Keystone RV Company

SAFETY ADVISORY # 19-348

Capital Two-Burner Cooktop

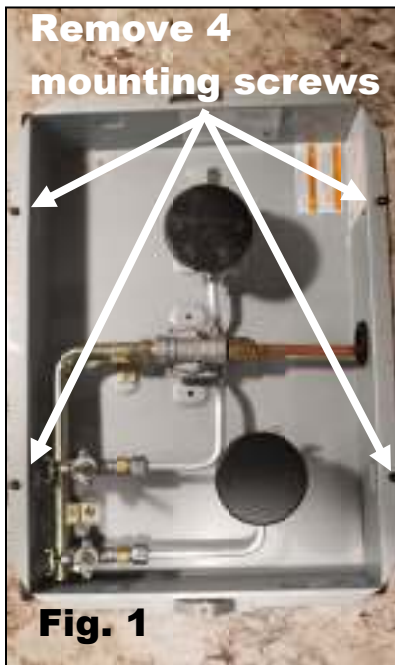
The remedy is to remove the existing interior Capital two-burner cooktop and install a Suburban cooktop in its place.

Remove the four screws mounting the box to the counter top (Figure 1), remove the propane gas supply line. Remove the remove the Capital burner box (discard).

Install KRV # 252380 - Range - Drop In - Outside Burner Box - Box Only, attaching the propane gas supply and installing 4 mounting screws. For more details see the installation instructions that come with the part.
